ADDENDUM

ADDENDUM No.	2	GMCa JOB #:	202507 MBD
ISSUE DATE:	04.24.26	SBC #:	366/009-07-2025
PROJECT:	MTSU Beasley Hall Renovations – Phase I		323 Friendship Street Murfreesboro, TN 37132
OWNER:	Middle Tennessee State University		1301 East Main Street Murfreesboro, TN 37132
ARCHITECT:	Gilbert McLaughlin Casella architects		2305 Kline Ave, Suite 200 Nashville, TN 37211

1 ENLARGED PLAN: LEVEL 1
SCALE: 3/8" = 1'-0"

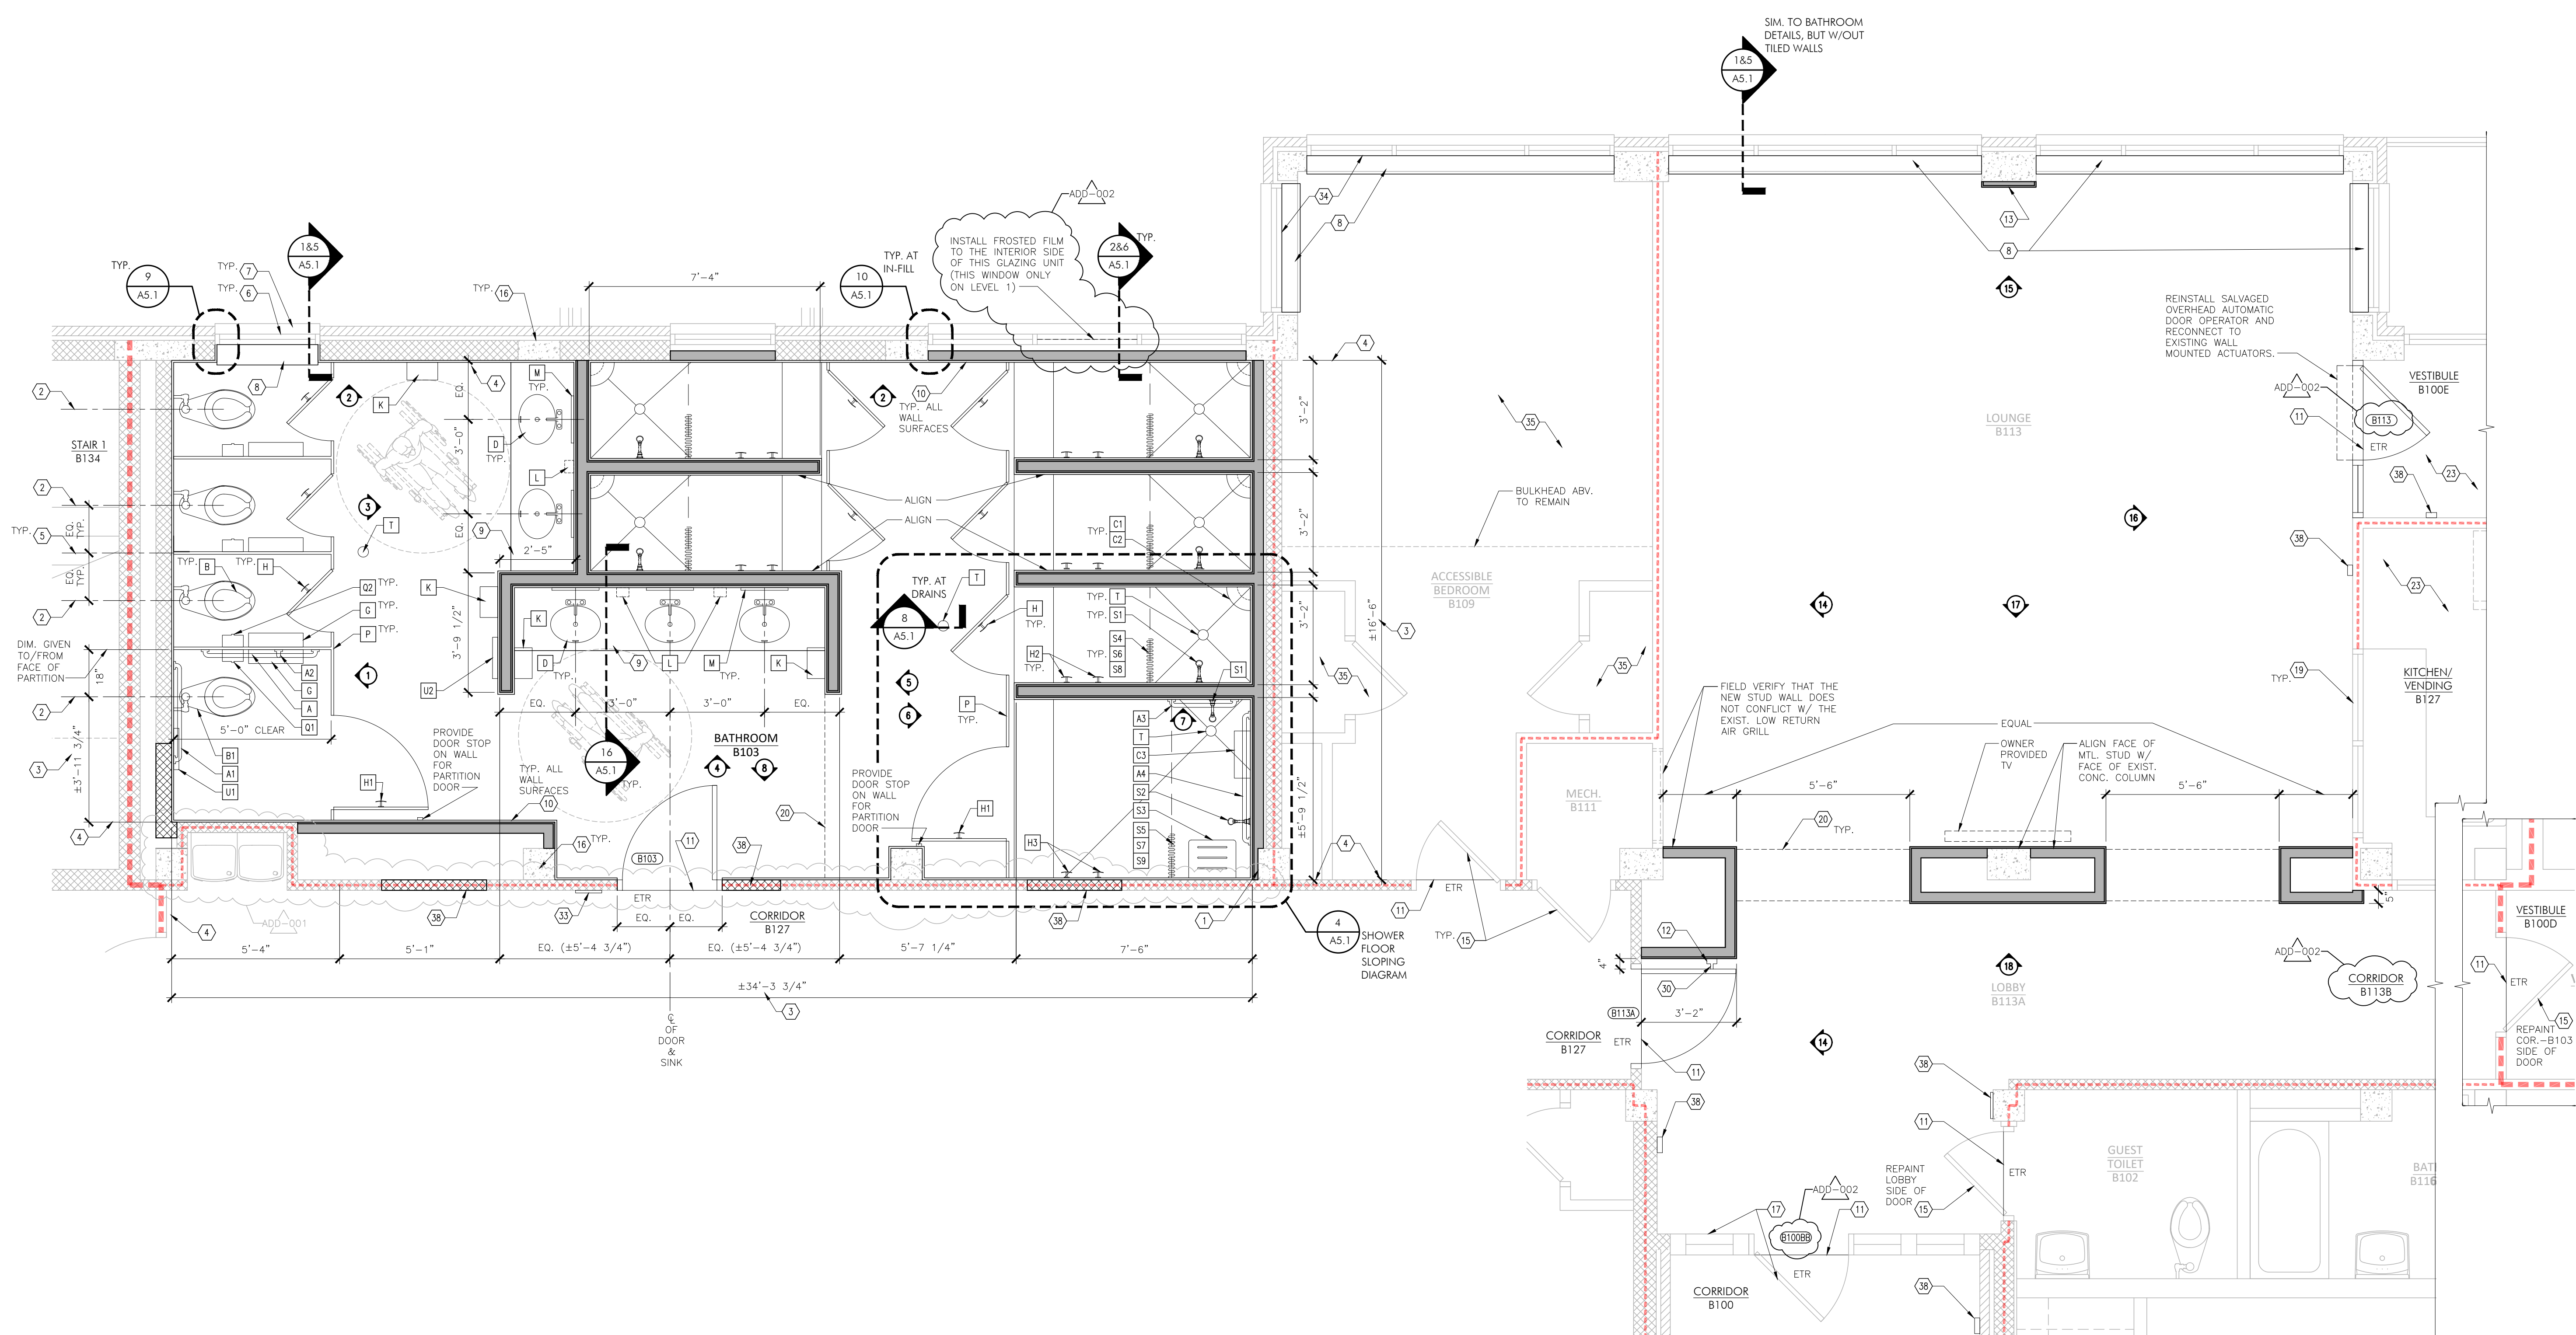
- 1) The following are general clarifications:
 - a) None.
- 2) The following are responses to questions provided by bidders:
 - a) *Question: Do the windows that are being infilled with Gyp need to have frosted film installed on them?*

- b) *Question: From B113 to vestibule B100E is labeled as B100E on a6.1 and as B113 on A1.1 – Clarify*
Response: Your question doesn't specifically mention "doors", but we're assuming you're referencing the

- a. Plan #1 -Level 1
 - i. Changed label for Corridor-B103 to be Corridor-B113B (B103 was already used at Bathroom-B103)
 - ii. Added film to one window unit in bathroom-B103.

- iii. Corrected door label between Lounge-B113 and Vestibule-B100E to be B113 (not B100E)
 - iv. Corrected door label between Lobby-B113A and Vestibule-B100 to be B100BB (not B100AA)

Response: On Level 1, the single-window in the existing bathroom and the right/left windows in the triple-window combination unit already have panels or film on the windows. However, yes, we will need to add film on the center-window of the triple-window combination unit. All the bathroom windows on Levels 2 & 3 are either already covered with existing panels/film or we have noted on the drawings for film to be added. This has been formally added to the Drawings in this addendum.

labelling of the door between Lounge-B113 and Vestibule-B100E. This door should be labelled B113. Sheet A1.1 is correct. Sheet A6.1 is incorrect. This has been formally corrected on the Drawings in this addendum.

1 LEVEL 1 FLOOR PLAN
SC: 1/8" = 1'-0"

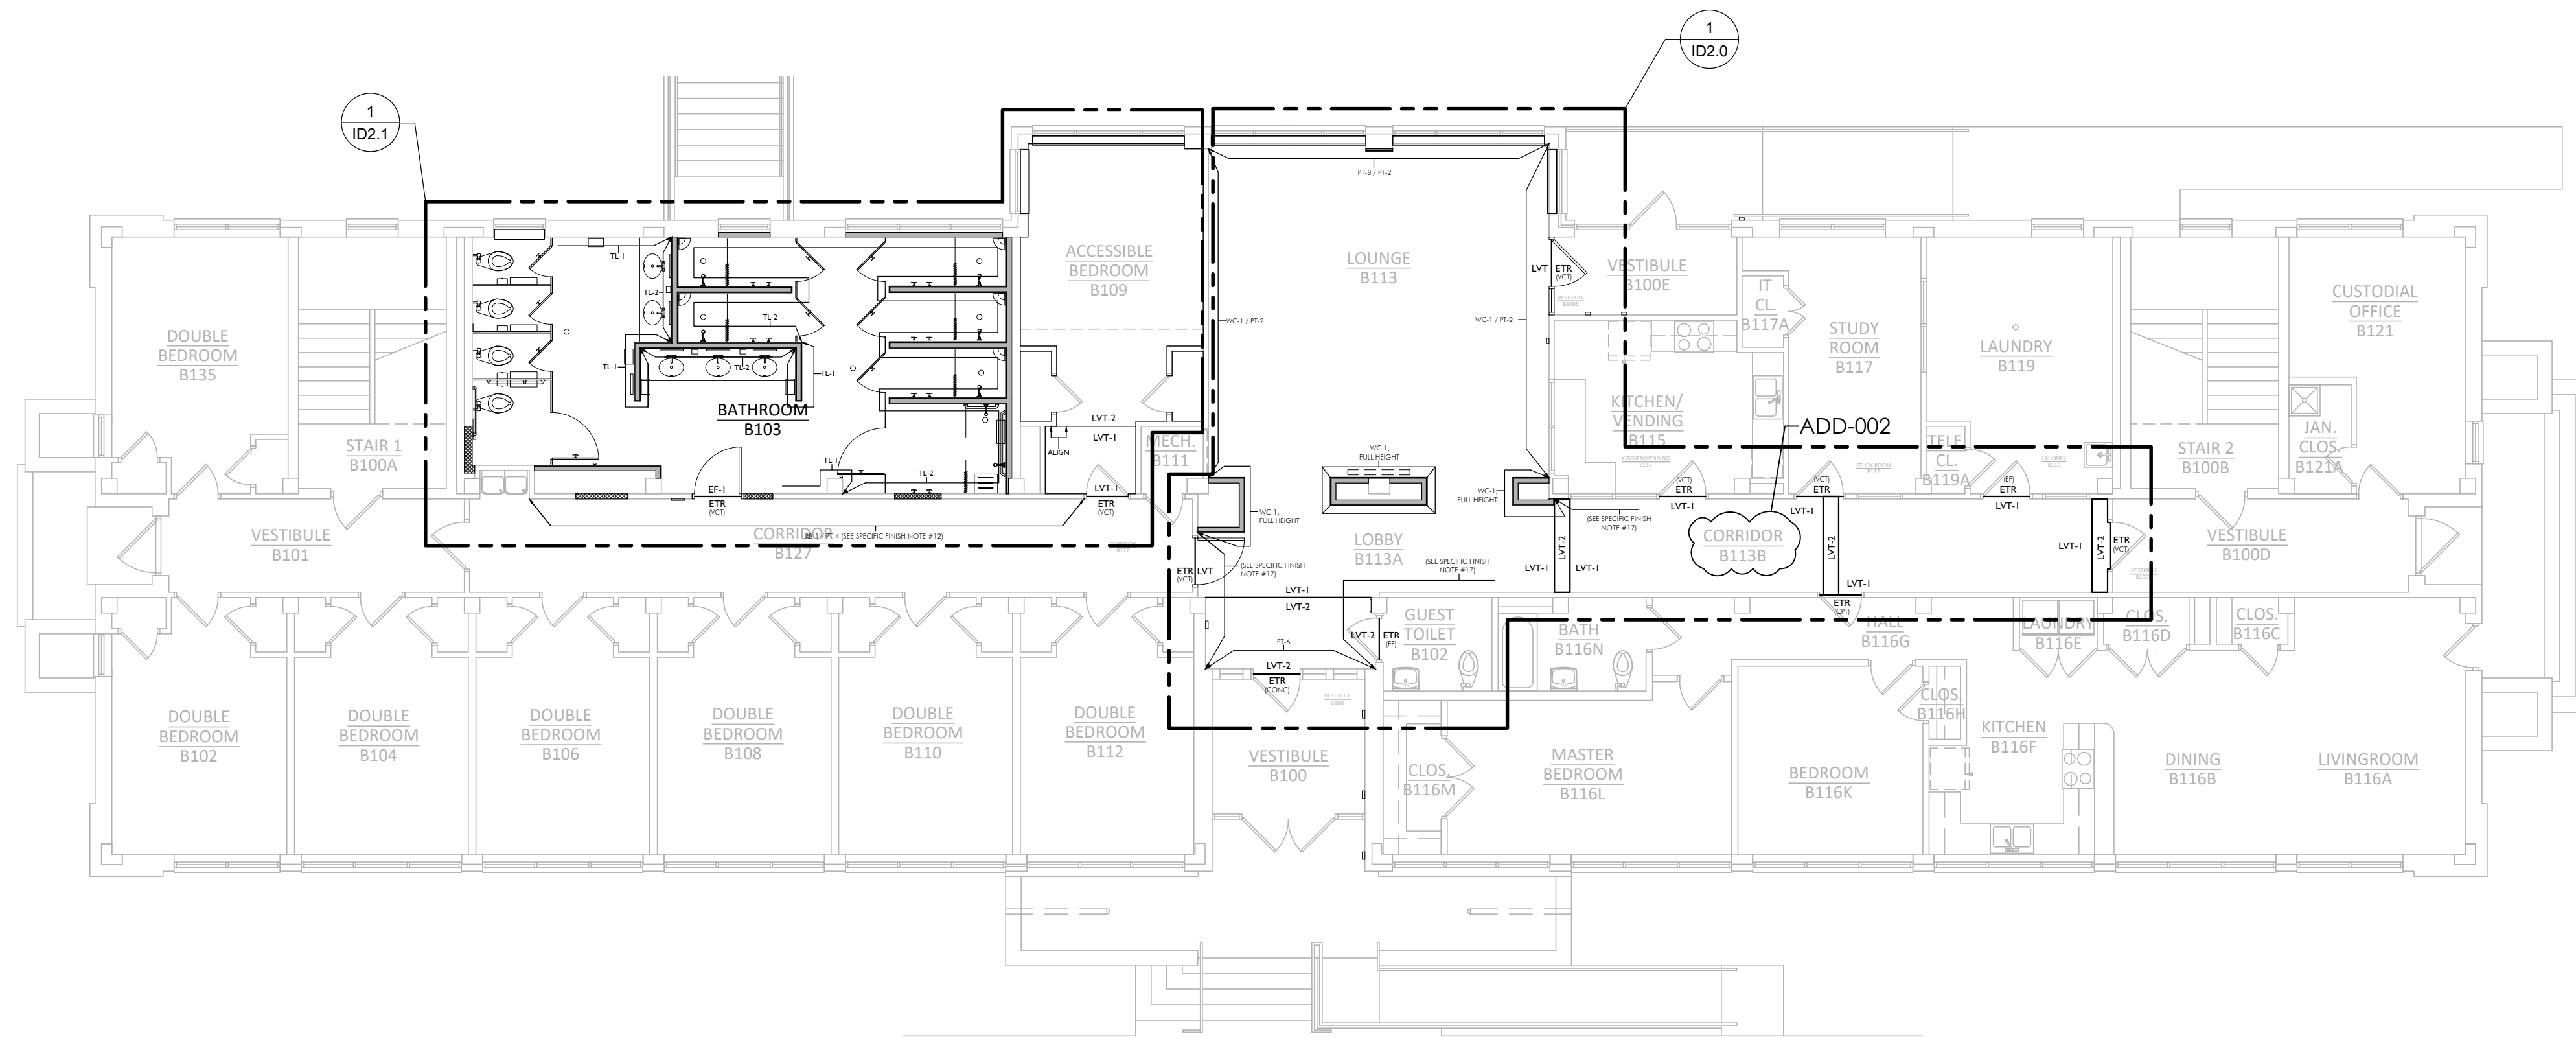
- 7. ID1.0 LEVELS 1, 2, & 3 FLOOR PLANS
 - a. On Plans #1 & #3-Level 1, Corridor-B103 was relabeled Corridor-B113B (the bathrooms on that floor were already labeled as B103).
